# UNITED STATES PATENT AND TRADEMARK OFFICE

APPLICATION NO.	FILING DATE	FIRST NAMED INVENTOR	ATTORNEY DOCKET NO.	CONFIRMATION NO.
10/723,569	11/26/2003	Wolfgang Beigang	GKNG 1184 PUS	9113
7590	10/25/2004		EXAMINER	
Robert P. Renke Suite 250 28333 Telegraph Road Southfield, MI 48034			NGUYEN, XUAN LAN T	
			ART UNIT	PAPER NUMBER
			3683

**Office Action Summary**

## **DETAILED ACTION**

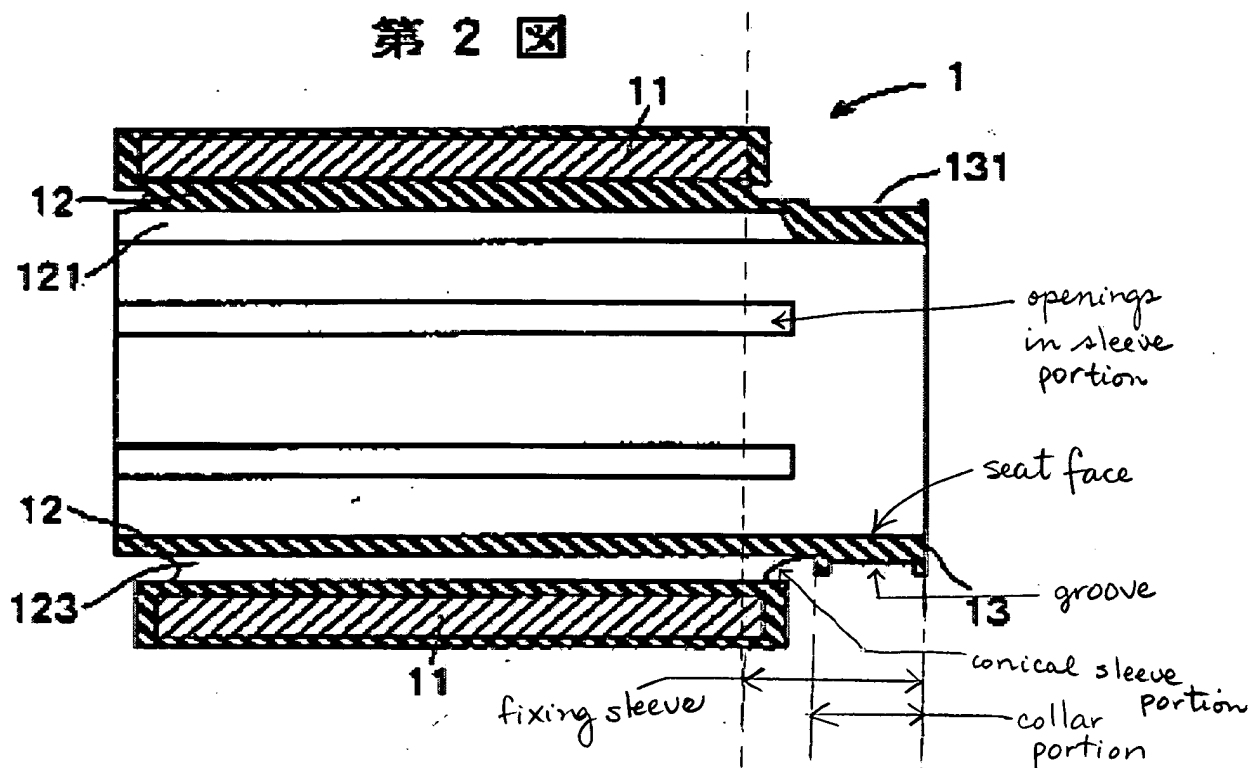
Re: claim 1, Hamada shows in figures 1 and 2, a vibration absorber for attaching to a rotatable driveshaft, as in the present invention, comprising: an annular-cylindrical mass member 11 arranged at a radial distance from the driveshaft; a plurality of circumferentially spaced elastic supporting elements 12 shaped to be positioned on the driveshaft, which are firmly connected to the mass member 11 and extending radially inwardly toward the driveshaft from the mass member; and an elastic fixing sleeve shaped to be positioned on the driveshaft and at one end connected to the mass member 11 (see below marked up figure 2).

Re: claim 4, figure 1 shows the supporting elements 12 each having a radial outside connected to one another to form an annular elastic member with one another.

Re: claims 5 and 6, figures 1 and 2 show the supporting members 12, the fixing sleeve and the mass member are integrally connected.

Re: claims 9 and 10, please see above for the marked up sleeve portion.

Re: claim 13, please see above for marked up groove to receive clamp band.

Re: claim 21, please see marked up openings in sleeve portion above.

Re: claims 15-17, Hamada shows in figure 2 the supporting elements to be connected to the mass member axially opposite of the fixing sleeve, an axial distance
